TSB:	26-003: M920029	Product:	Lineage M-Series 25FW
Date:	5/13/2026	Repair Time:	0.5h

This bulletin describes the procedure to relocate the LP solenoid power source from the chassis battery to the house battery on Lineage M-Series 25FW units equipped with an LP solenoid. The relocation uses retrofit harness EL-0189.

Fig. 7 – Harness routed through spare rubber grommet in step box wall.

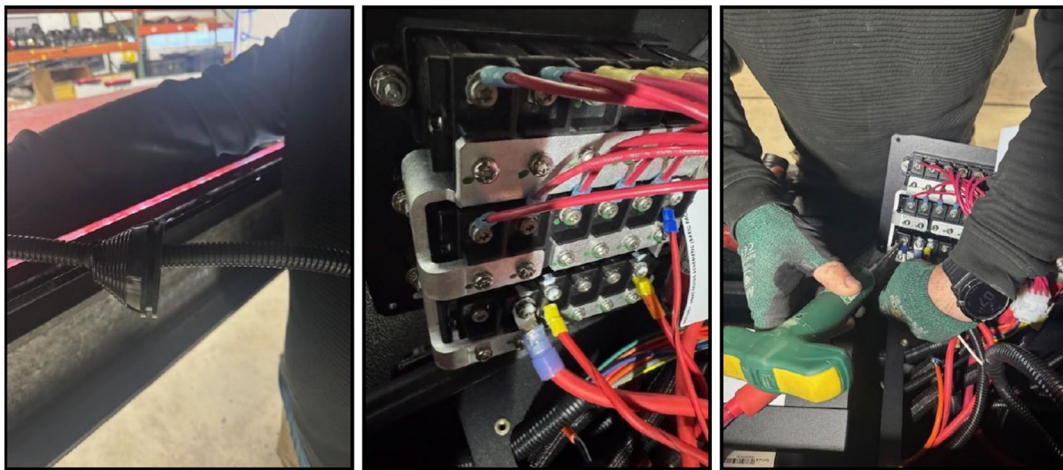
Step 3 – Route the new harness down the passenger side of the frame and into the step box, passing through the spare rubber grommet in the side of the step box.

Note: Use the existing spare grommet – do not drill a new opening through the step box wall.

Fig. 10 — LP shut-off switch tested — indicator illuminated when energized.

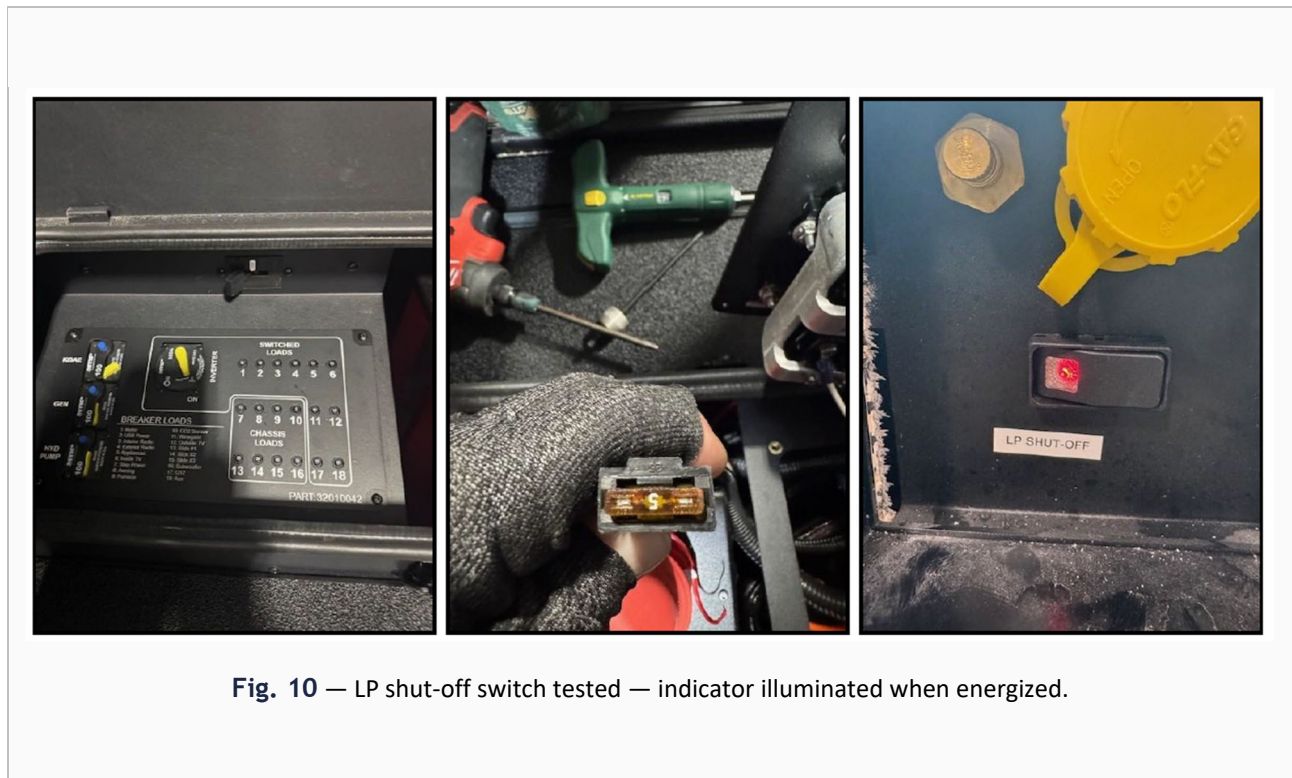
Step 5 — Test the LP shut-off switch. Confirm the LP solenoid energizes and de-energizes as the switch is cycled.
